FIRE CLEARANCE GRANTED SUBJECT TO FOLLOWING CONDITIONS:-(Ref. Letter No. F6/DFS/MS/2010/2495 dated 27.08.2010 from Delhi Fire Services)

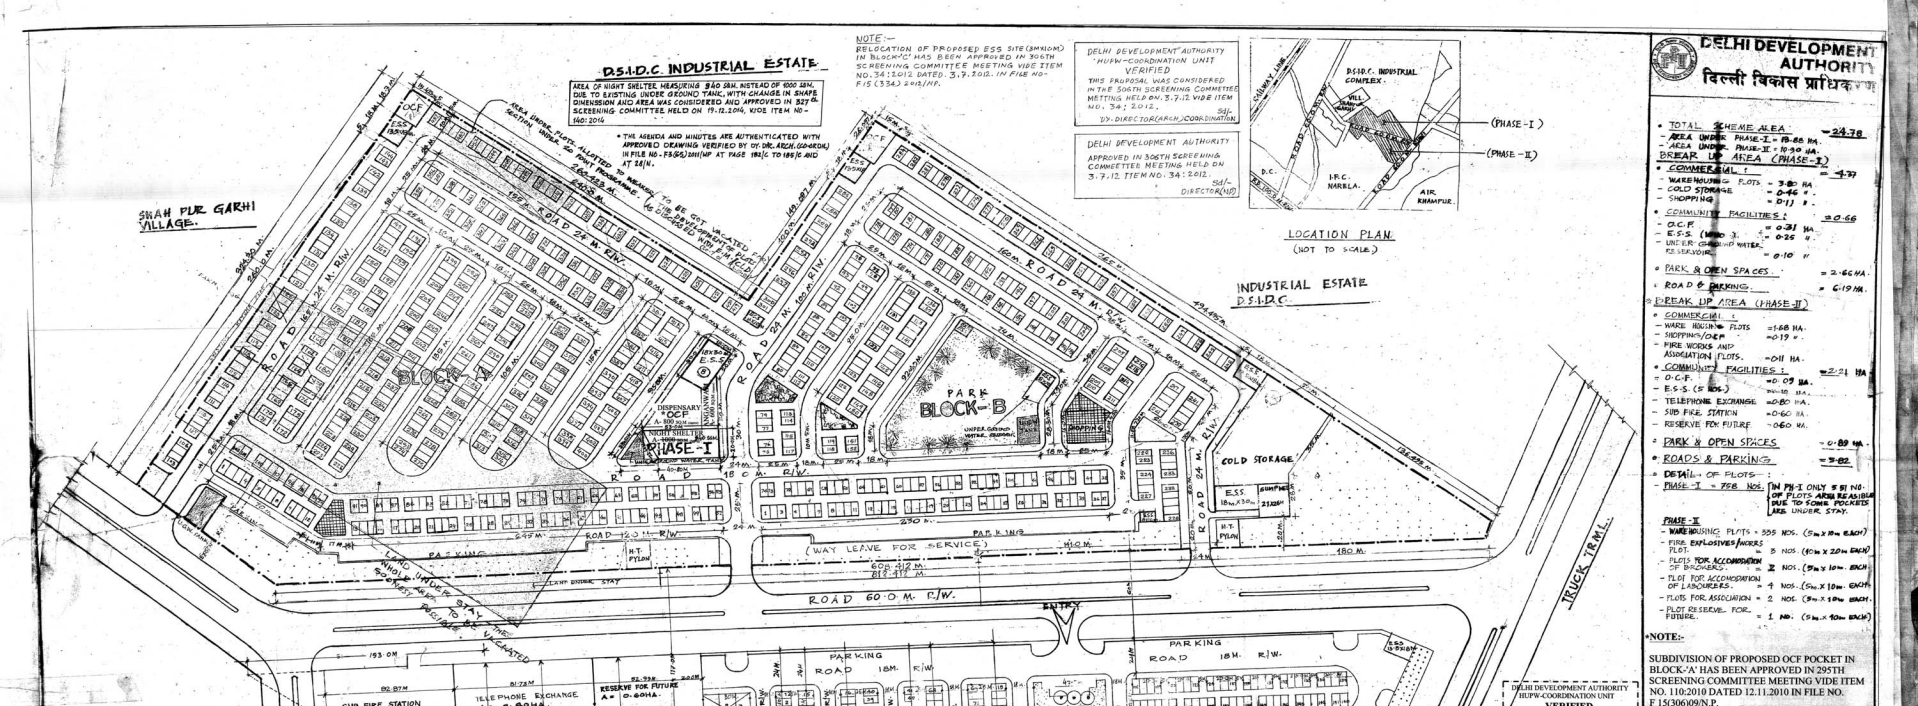
1. MAIN ENTRANCE TO THE PREMISES SHALL BE OF ADEQUATE WIDTH TO ALLOW EASY ACCESS TO THE FIRE FIGHTING APPLIANCES AND IN NO CASE IT SHALL BE MEASURED LESS THAN 4.5 MTR. THE ENTRANCE GATE SHALL FOLD BACK AGAINST THE COMPOUND WALL OF THE PREMISES THUS LEAVING THE EXTERIOR ACCESS WAY WITHIN THE PLOT, FREE FOR MOVEMENT OF FIRE SERVICE VEHICLES. THE ARCHWAY, IF ANY, SHALL NOT BE AT A HEIGHT LESS THAN 5 MTR.

2. THE INTERNAL APPROACH ROAD SHALL BE KEPT FREE OF ALL HINDRANCES SUCH AS PLANTERS, PARKING, STREET LIGHT POLLS, CHAJJAS, ETC FOR THE EASY MOVEMENT OF FIRE APPLIANCE. THE LOAD BEARING CAPACITY OF INTERNAL APPROACH ROAD SHALL BE CAPABLE TO TAKE THE LOAD OF FINE ENGINE.

3. THE DISTANCES FROM ELECTRICAL OVERHEAD LINES SHALL BE AS PER INDIAN ELECTRICITY RULES.
4. ALL AROUND ROAD OF 12 MTRS AS PROPOSED IN THE PLANS SHALL BE MADE AVAILABLE. THUS THE UNIT/SHOP NO. 228 AND E.S.S. MAY BE RELOCATED TO ENSURE THIS.(IN THIS REGARD REPEAL CONDITION NO. 1)

5. THE WIDTH OF THE STAIRCASES SHALL BE 1.5 MTR AS PER NBC-IV. (IN THIS REGARD REPEAL CONDITION NO-12)
6. 05 NO'S OF UNDERGROUND WATER STORAGE TANKS OF CAPACITY 2,00,000 LTRS AS PROPOSED IN THE PLANS SHALL BE PROVIDED WITH SUITABLE NUMBERS OF MANHOLES AND REPLENISHMENT FACILITY AT THE RATE OF 1000 LPM. THE FILLING OF UNDERGROUND WATER STORAGE TANK SHALL BE SO ARRANGED THAT OVER FLOW OF FIRE TANK SHALL FEED THE DOMESTIC TANK TO AVOID STAGNATION IN FIRE TANK. THE TANKS SHALL BE APPROACHABLE TO FIRE VEHICLES.

7. THE YARD HYDRANT NETWORK WITH SUITABLE PUMPING ARRANGEMENTS SHALL BE PROVIDED IN THE ENTIRE COMPLEX AS PER BIS 13039-1991.
8. THE INDIVIDUAL UNITS/ SHOPS SHALL BE PROVIDED WITH AUTOMATIC DETECTION AND SPRINKLER SYSTEM EXCEPT THE SHOPS/ UNITS DEALING WITH WATER REACTIVE CHEMICALS. THE SYSTEM MAY BE GIVEN EXTENSION FROM THE YARD HYDRANT LINE AND FACILITY OF FIRE BRIGADE INLET SHALL ALSO BE PROVIDED AT THE JUNCTION.

9. EACH BLOCK OF 5 SHOPS/ UNITS SHALL BE PROVIDED WITH OVERHEAD TANK OF 5,000 LTRS, TERRACE PUMP OF 450 LPM CAPACITY AND ONE HOSE REEL.
10. DIFFERENT TYPES OF CHEMICALS SHALL BE STORED SEPARATELY BY TAKING PROPER CONSIDERATION OF MATERIAL SAFETY DATA SHEET (MSDS) UNLESS THEY ARE SEPARATED BY A WALL OF 04 HR FIRE RESISTANCE RATING. ACCORDINGLY 04 PLOTS SHOWN ADJACENT TO EACH OTHER MAY BE USED FOR STORAGE OF SAME CHEMICAL.

B. THE CONDITION NO-6 SPECIFICALLY RELATED TO UNIT/SHOP NO 228 HAS BEEN WITHDRAWN BY DFS VIDE LETTER NO. F6/DFS/MS/2010/3346 DATED 12-09-2010 AS IT MAY LEAD TO LITIGATION SINCE THE PLOT BUILT-UP ALLOTTED IN 2ND AND 2A-2ND WIDE ROAD IS AVAILABLE IN GROUP DEPTT. FILE. (IN THIS REGARD REPEAL CONDITION NO-6 OF THE APPROVAL BY DFS, THE STANDARD PLANS OF 100 PAX & 125 PAX HAS ALREADY BEEN REVISED WITH STAIRCASE HAVING WIDTH 1.5M. AND APPROVED BY S.C. OF DDA IN ITS 296TH MEETING HELD ON 19-12-2000 VIDE ITEM NO-194:2000.
